**TITLE:** Wellhouse Crescent Flooding  
Surface Water Management Opportunities Workshop 3

**DATE:** Wednesday 17<sup>th</sup> November 2021 Time: 10.00am- 12.30pm

# Notes of Meeting

**(D) Small Scale Green Roof Retrofit**

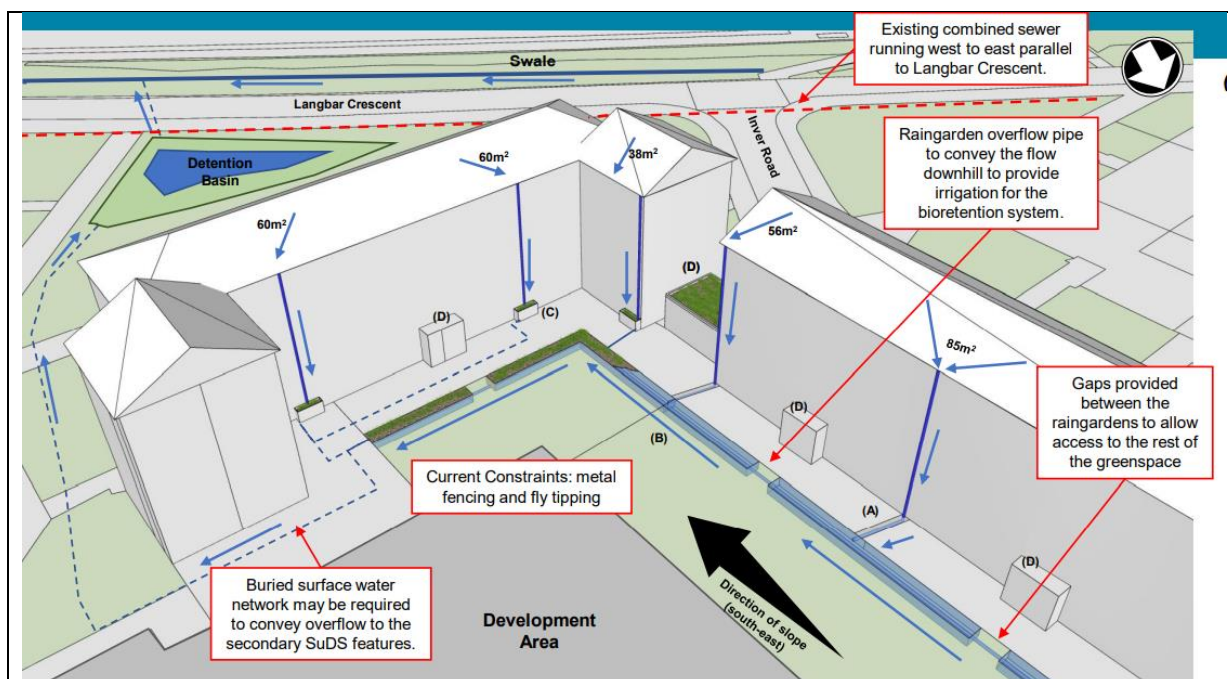
DH also noted that Scottish Power may need to be consulted around Green Roof on electrical substation and check would be required on load bearing capacity.

## Opportunities for Public Areas

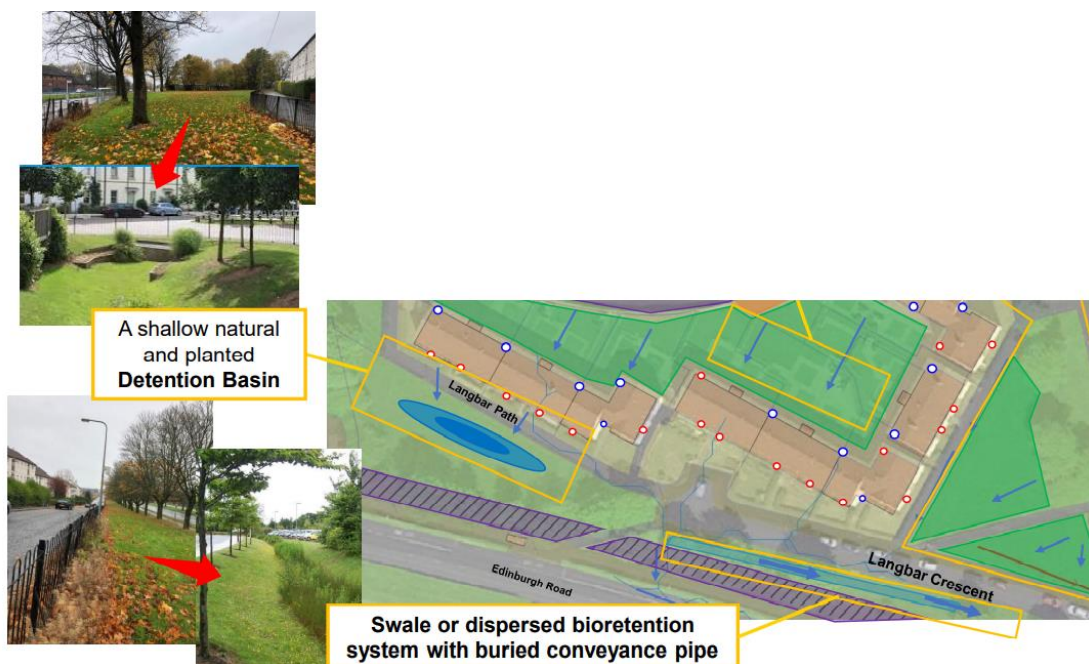
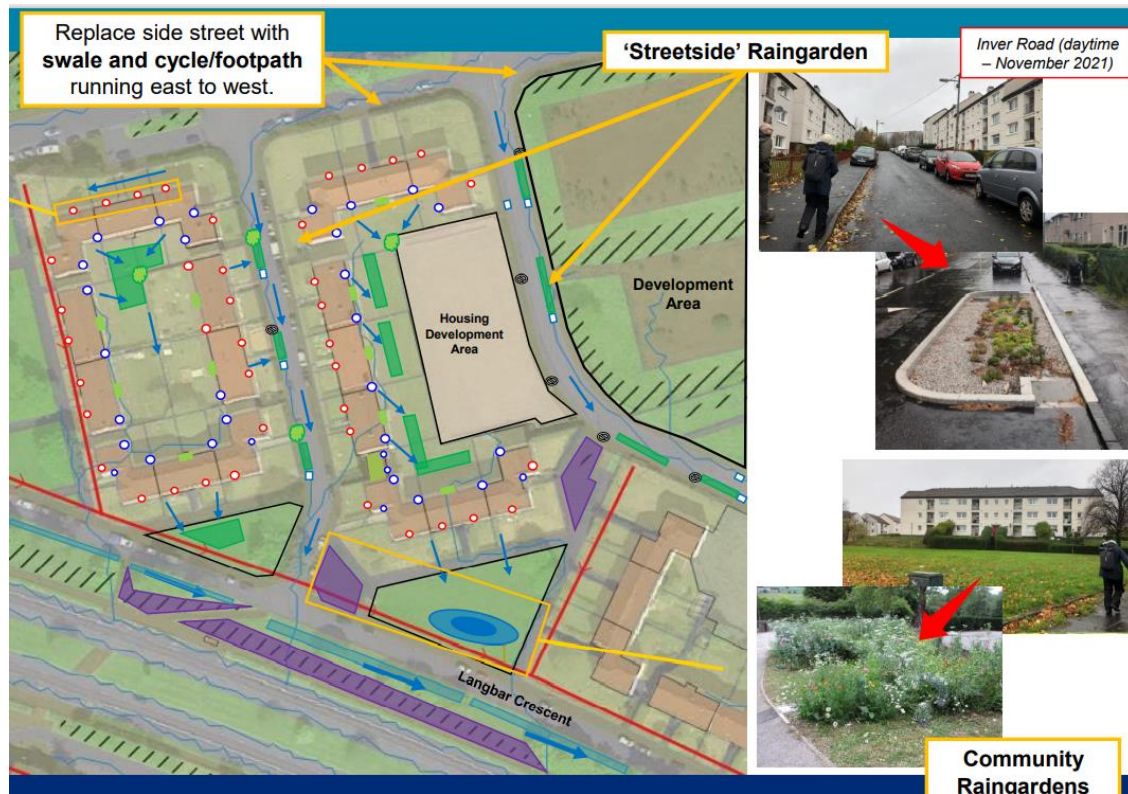
DH noted that some of the streets highlighted for streetside raingardens were narrow with cars already parking on the pavement. GCC have been involved in trying to implement similar measures at Croftpark Avenue in the southside of the city and there has been a lot of community resistance to removal of parking spaces.

BF mentioned we would need to be careful that any works do not provide an overall detriment to on street parking.

RH highlighted the opportunity to tie new developments into the plans. RH suggested that softer landscape features where possible would be preferable to buried drainage modules. RH also suggested a swale at bottom of slope in Edinburgh Road would be better than a swale at top of slope in adjacent Langbar Crescent.

### Langbar Crescent Storm Flow Overflow (SSO)

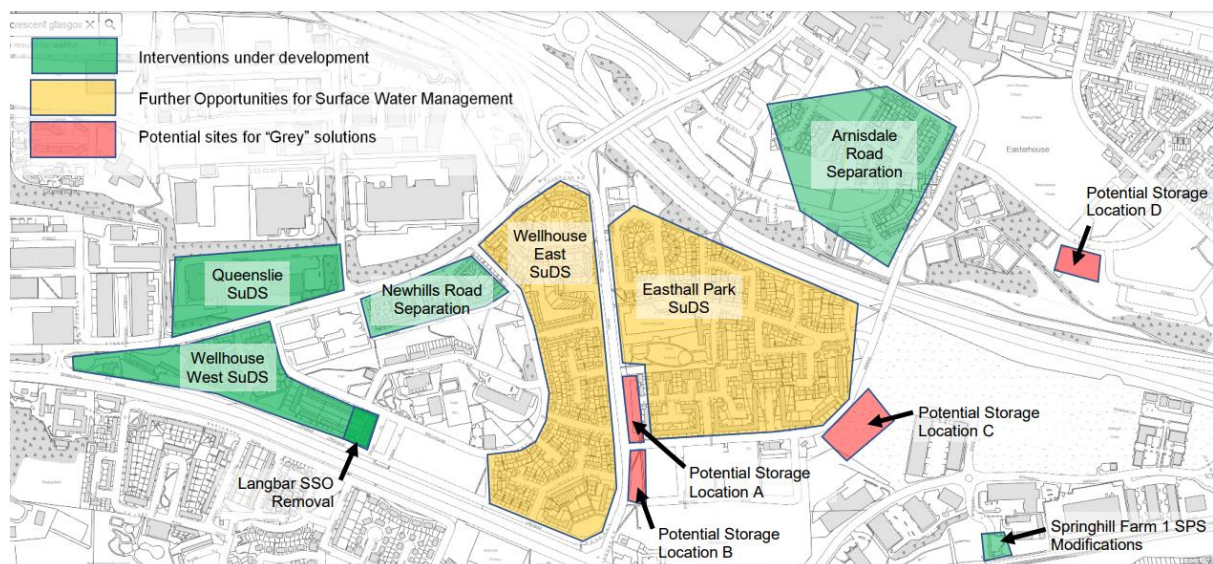
RH noted that it was good to see plan and land take for basin and that it would also be good to see cross sections. RH thinks this basin could be a focus for the community and improving the area. RH also thinks we should not be constrained by layouts of existing streets if there is opportunity to change them for the better.

BF mentioned that Roads Scotland Act does not allow discharge of overflow water onto roads. MMcW clarified that the proposal would be to remove the road at Delny Place and there would be no discharge onto a carriageway.

DH asked if we were to stop up Delny Place would this be Mic Ralph's team who would review the proposals. BF confirmed it would be.

DH asked if there had been a utility check of the proposed area as this can often have a big impact on cost and construction. MMcW confirmed that existing utility information has been obtained.
